ADDENDUM NO. 01 JUNE 5, 2023

Your attention is directed to the following interpretations of, changes and additions to the Contract Documents for the project, “Windows and Siding Replacement” at Syracuse Hancock International Airport (SYR) in Syracuse, New York.

PROPOSED SEATING LAYOUT - SOUTH CONCOURSE GATES 11

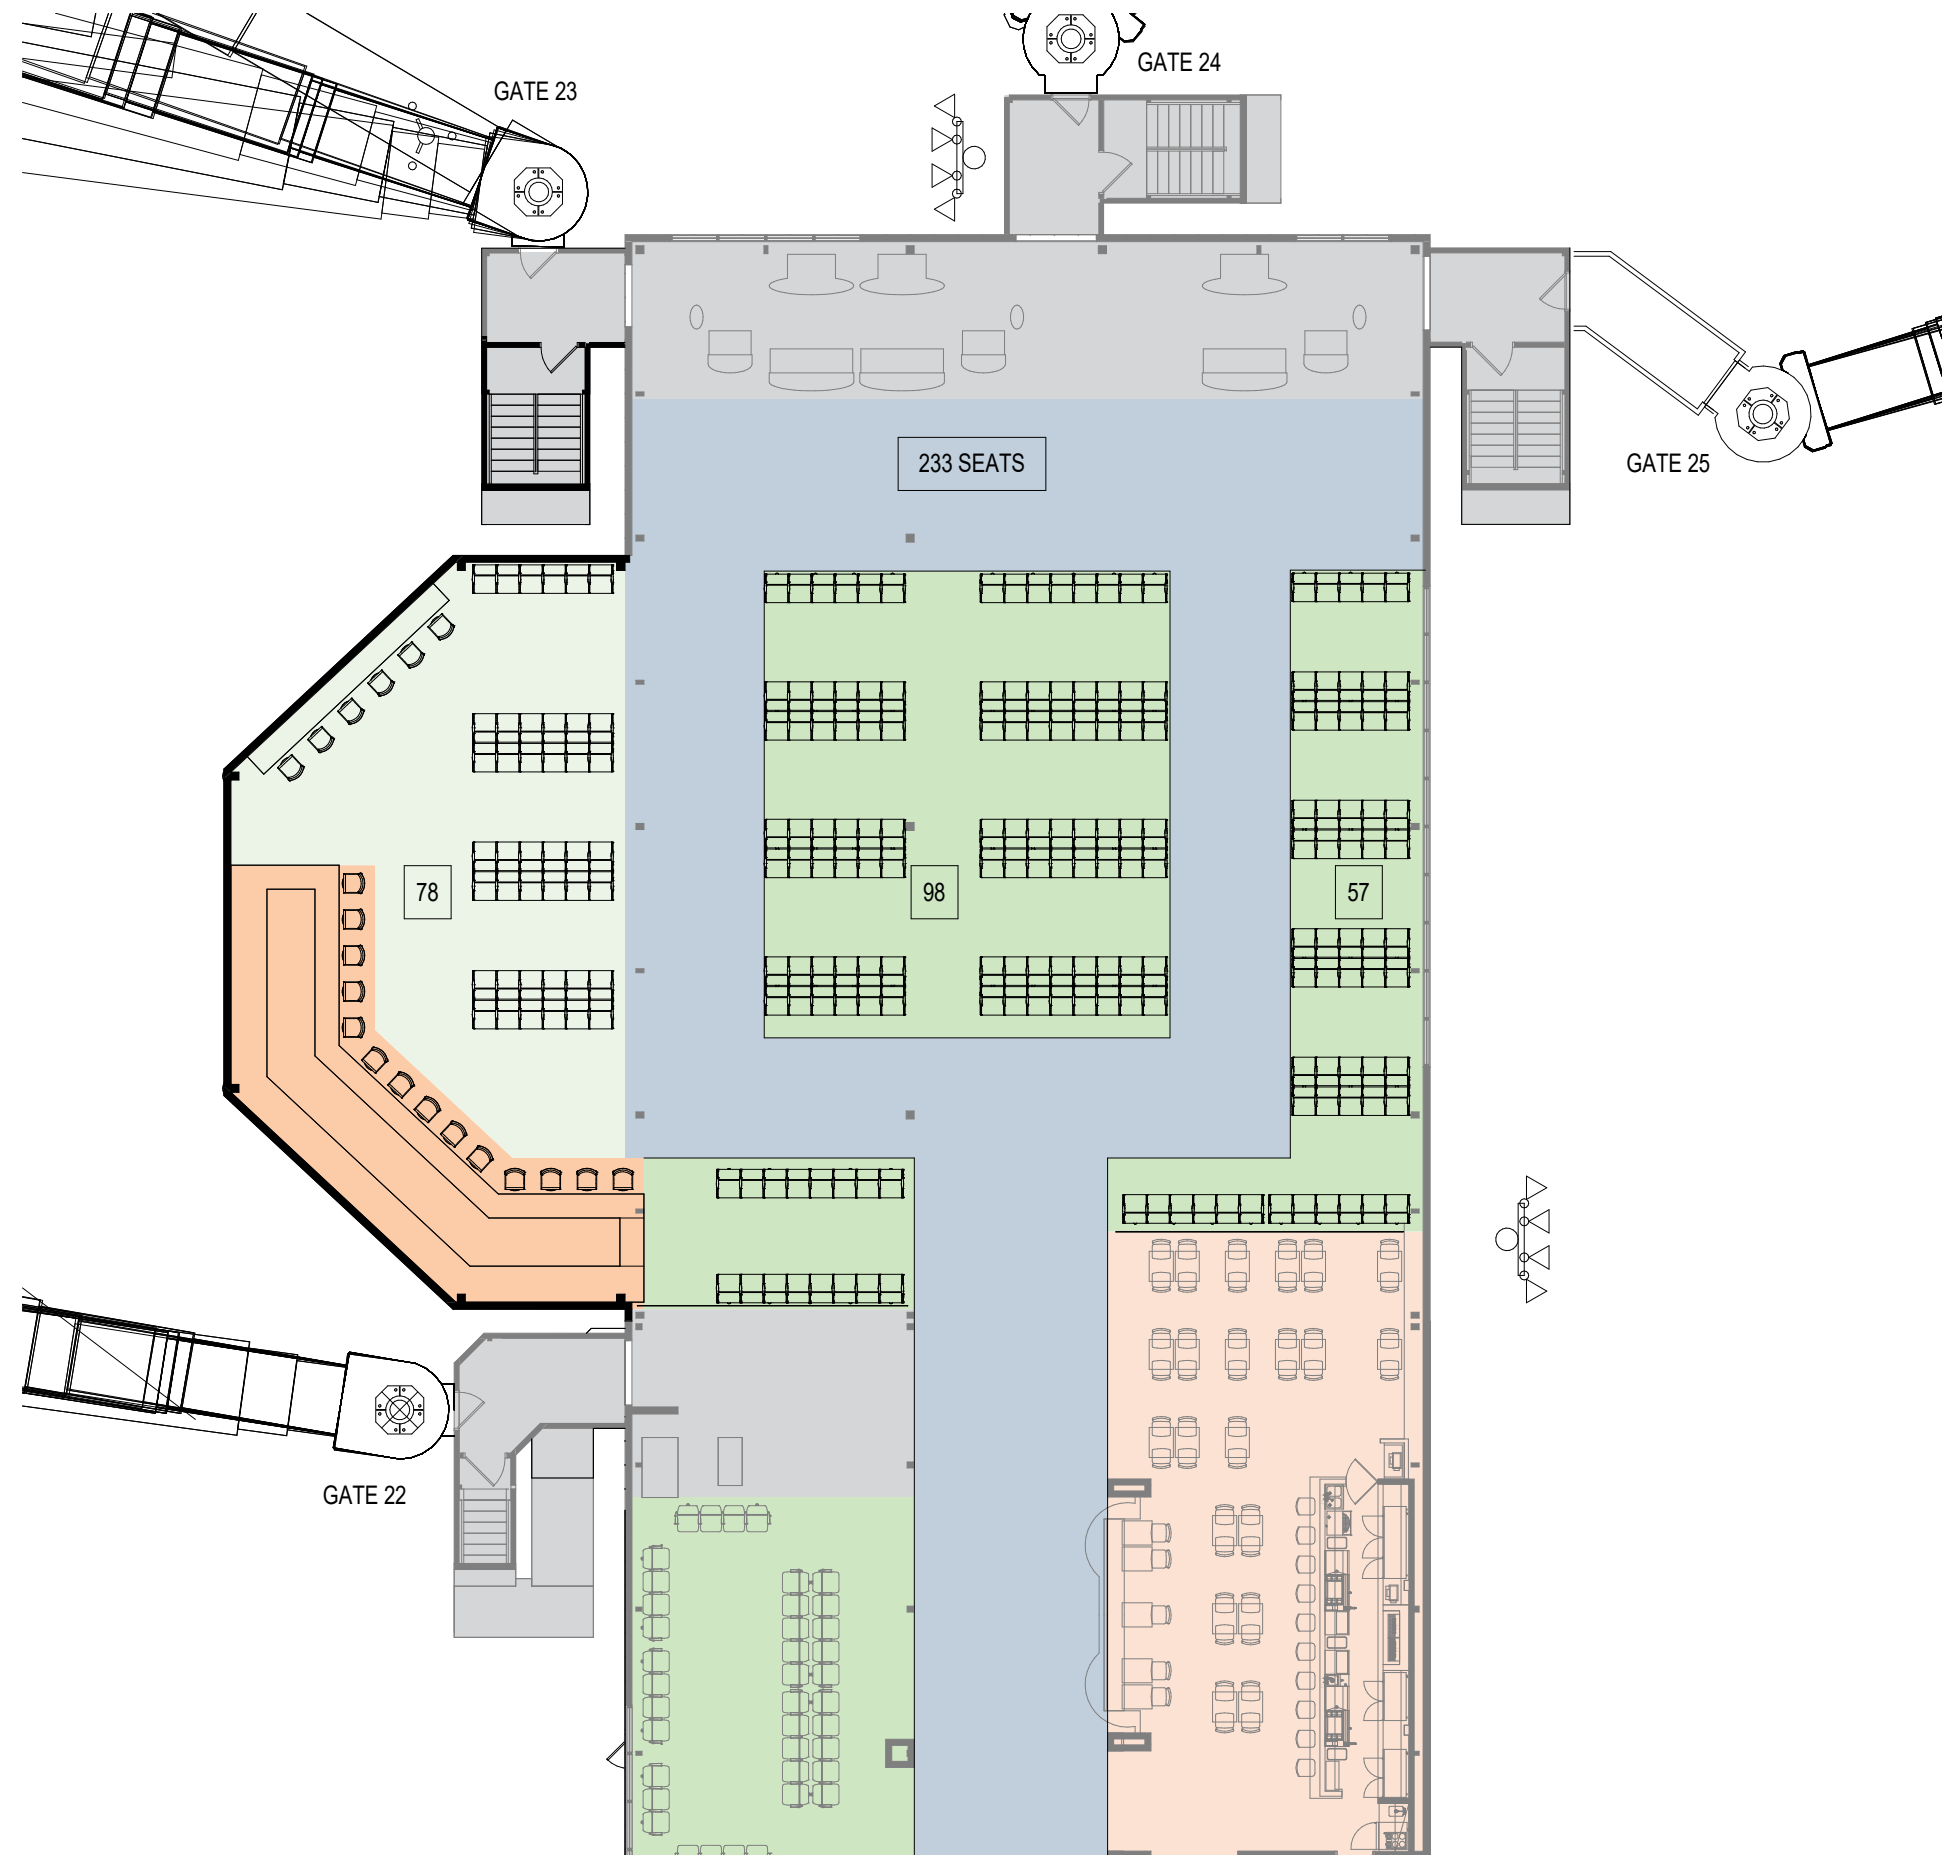
4. North and South Concourse Proposed Expansions
